Access Compliance Report

Public Rights-of-Way

(Curb Ramps)

Intersection ID: 32311	Main Street: LAUREL_WALK_CT	Cross Street: NEW_PROVIDENCE_LN	Location: NE
ADA ID: A7D0022AC863	Ramp Type: BlendTrans1	Initial Pass/Fail: Fail	Overall Compliance: No
		Severity Score: 10

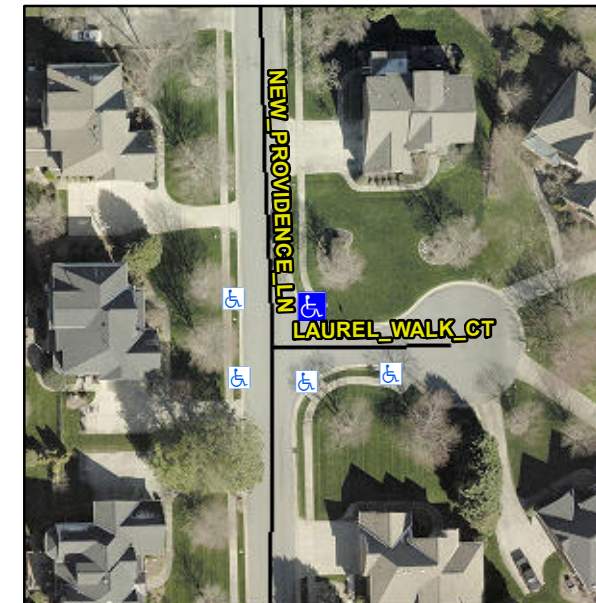
Not Found, R304.5.1, R304.5.3

Compliance	Description	Data	Compliance	Description	Data
N/A	Ramp Length (in)	48.0	Yes	BlendTrans Slope (%)	4.7
No	Ramp Width (in)	36.5	No	BlendTrans XSlope (%)	3.3
N/A	Flare Type LT	N/A	N/A	Flare Type RT	N/A
N/A	Flare Slope LT (%)	N/A	N/A	Flare Slope RT (%)	N/A
N/A	Flare Traversable LT?	N/A	N/A	Flare Traversable RT?	N/A
N/A	Landing Length (in)	N/A	N/A	DWS Provided?	N/A
N/A	Landing Width (in)	N/A	N/A	DWS Contrast?	N/A
N/A	Landing Slope (%)	N/A	N/A	DWS Length (in)	N/A
N/A	Landing X Slope (%)	N/A	N/A	DWS Full Width?	N/A
N/A	Landing Curb? (Y/N)	N/A	N/A	DWS Offset (in)	N/A
N/A	Shared Landing?	N/A			
N/A	Gutter Ponding?	N/A	N/A	Gutter Slope (%)	N/A
N/A	Gutter Lip Ht (in)	N/A	N/A	Gutter X Slope (%)	N/A
N/A	Painted X Walk1?	No	N/A	Painted X Walk2?	No
	X Walk 1 Direction	To W		X Walk 2 Direction	To S
	X Walk 1 Width (in)	N/A		X Walk 2 Width (in)	N/A
	X Walk 1 Slope (%)	2.2		X Walk 2 Slope (%)	6.7
	X Walk 1 X Slope (%)	6.1		X Walk 2 X Slope (%)	0.2

N/A	Ramp inside XWalk1?	N/A	N/A	Ramp inside XWalk2?	N/A
	Road Slope (%)	3.1		Clear Space?	N/A
	Road X Slope (%)	5.7	N/A	Clear Space to XWalk (in)	N/A
N/A	Any Obstructions?	N/A	N/A	Storm Grate/Utility Hazard?	N/A
	Obstruction Type			Storm Grate/Utility Type	
		N/A			N/A
			Yes	Surface Condition? (G/P)	Good
			No	Curb Slope (%)	6.3

Remove & Replace Curb Ramp With Two New Directional Ramps or Equivalent.
